**R E C O R D   O F   D E C I S I O N**

**F I N A L   E N V I R O N M E N T A L  
I M P A C T   S T A T E M E N T   &  
P L A N N I N G   G U I D E L I N E S**

**T H E   L E T T E R M A N   C O M P L E X**

**P R E S I D I O   O F   S A N   F R A N C I S C O  
M A Y   2 4 ,   2 0 0 0**

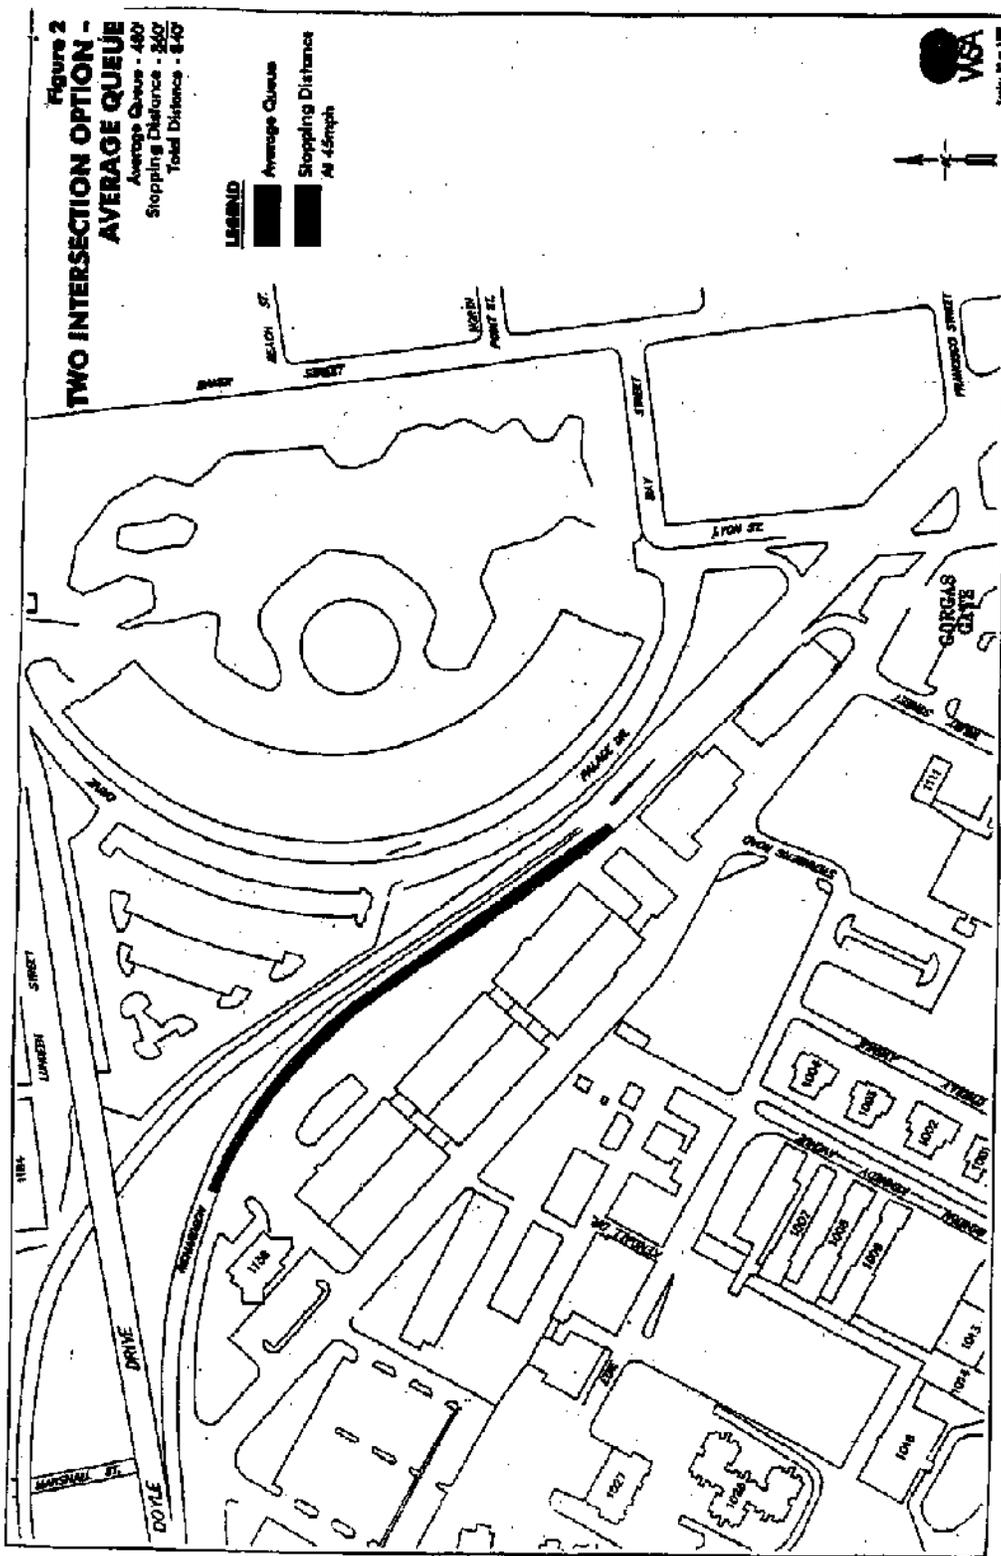
Figure 1 depicts the average and maximum queue at the current intersection for existing traffic conditions. Figures 2 and 3 depict the average and maximum queue lengths at the intersections proposed in the EIS/EIR for future traffic conditions (as described above). These figures also indicate the stopping sight distance required for a travel speed of 45 mph, or 360 feet (the speed limit is 45 mph on Doyle Drive upstream of the diverge, with 40 mph posted on the end of the curve on Richardson Avenue).

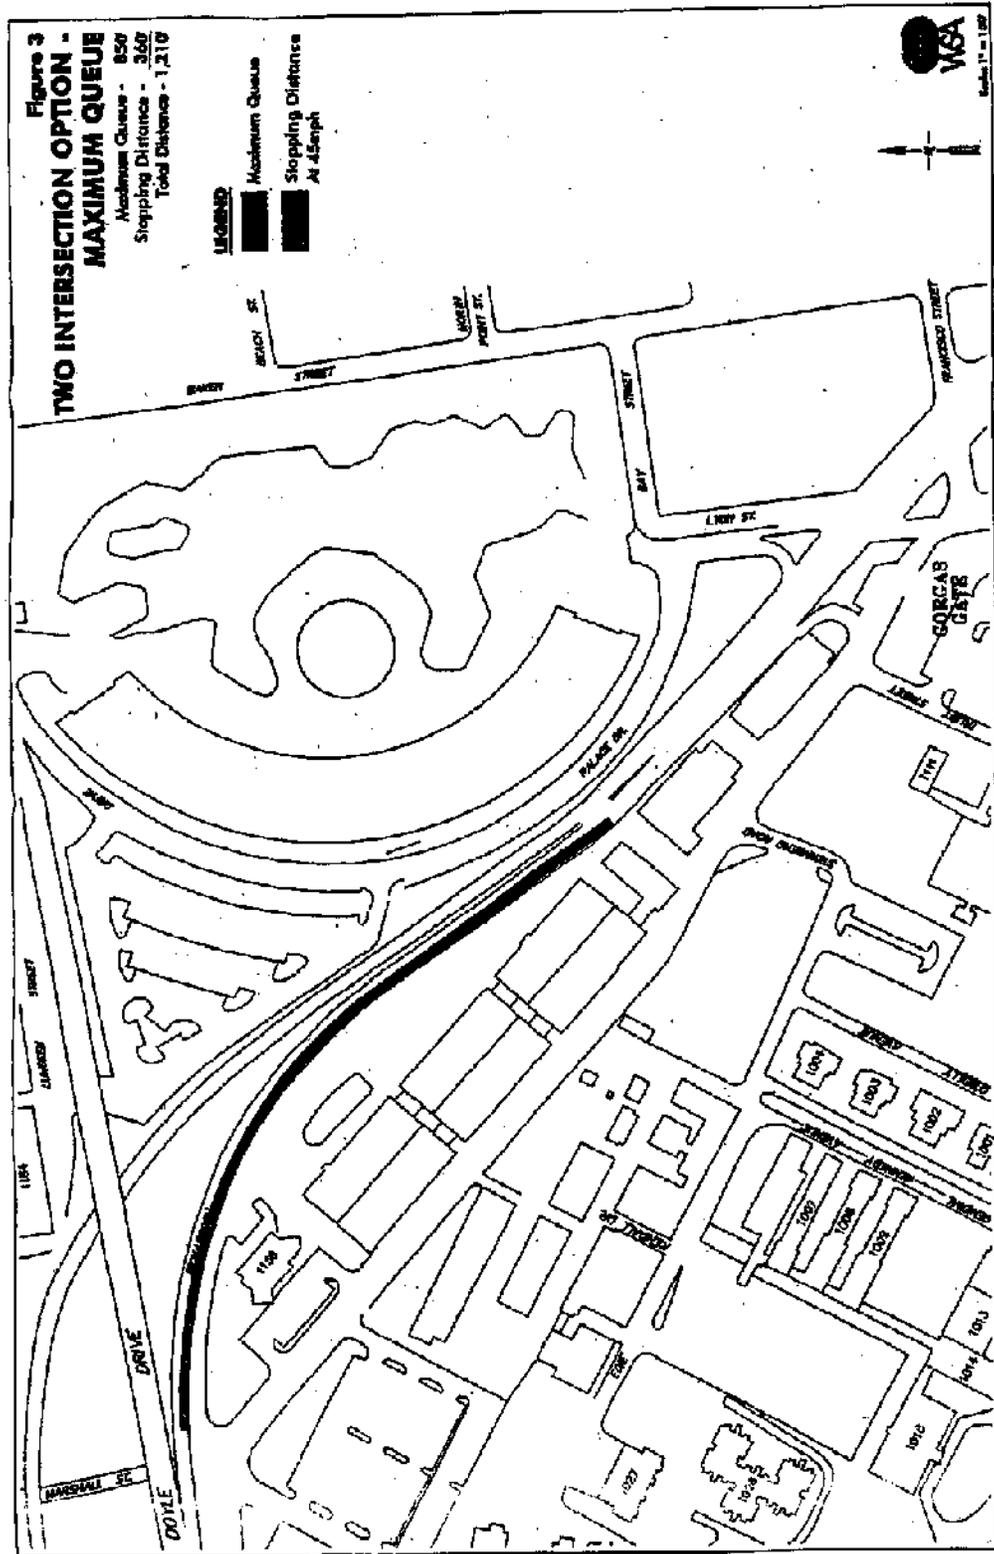
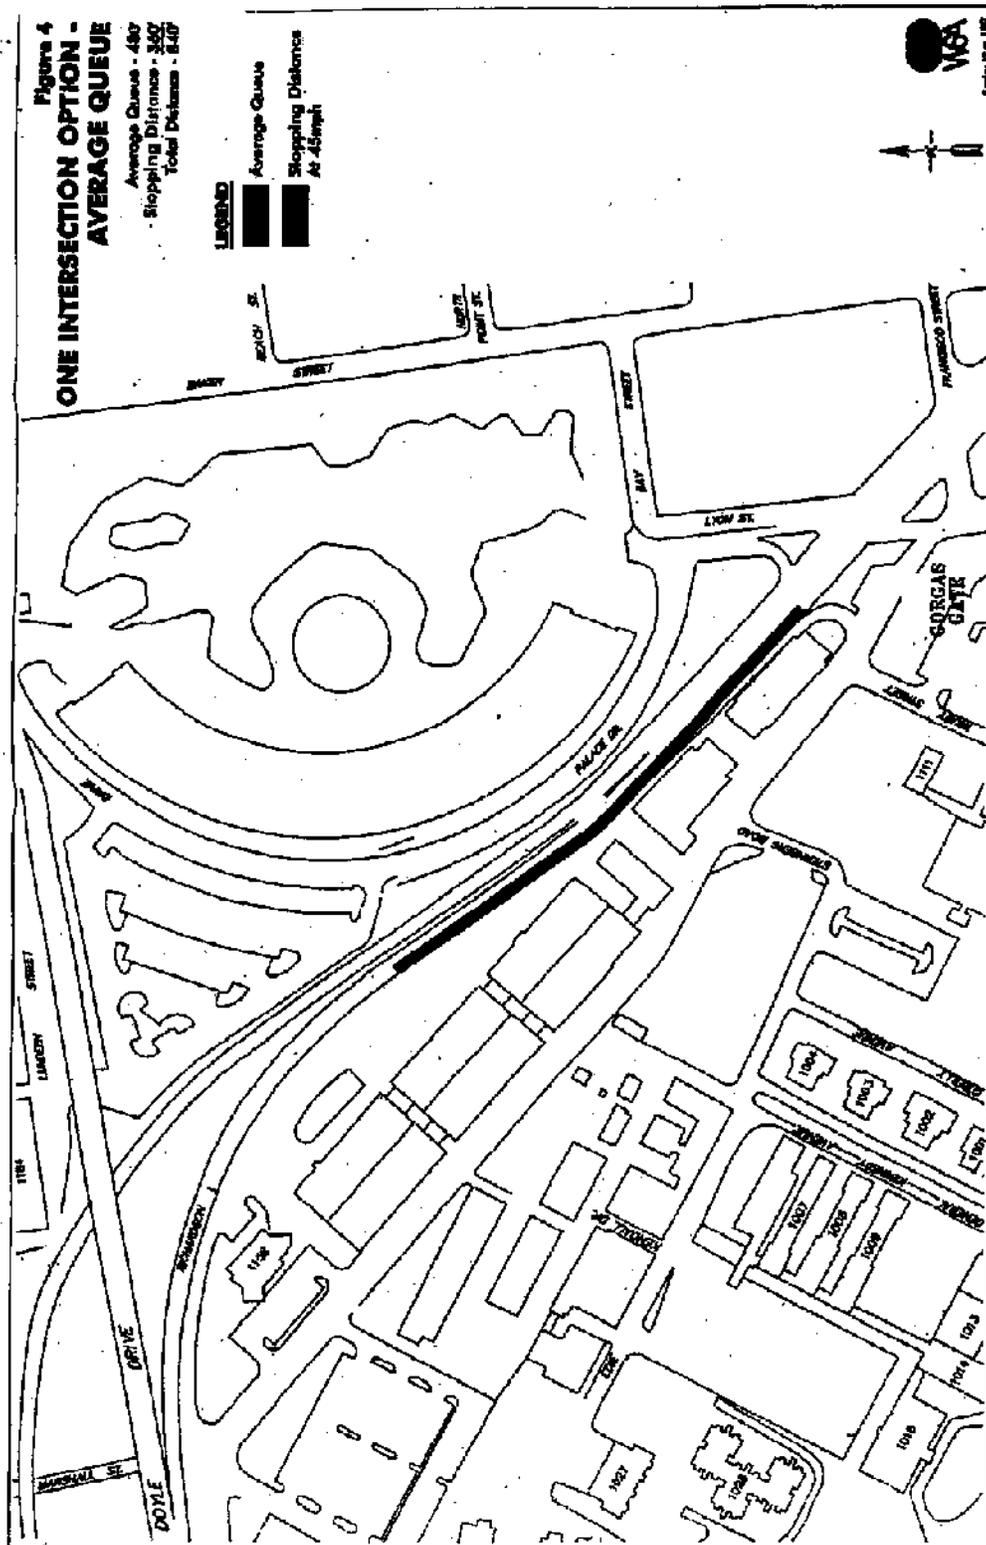
As Figures 2 and 3 in the attached memorandum show, queues behind the proposed western intersection will typically extend onto the curved ramp during the AM peak hour. However, the stopping sight distance problem is improved considerably if stops at that intersection are eliminated in the AM peak. Figure 3 shows that the required stopping sight distance for the average queue is on the roadway tangent while Figure 4 indicates that the required stopping sight distance for the maximum queue extends slightly onto the curved ramp.
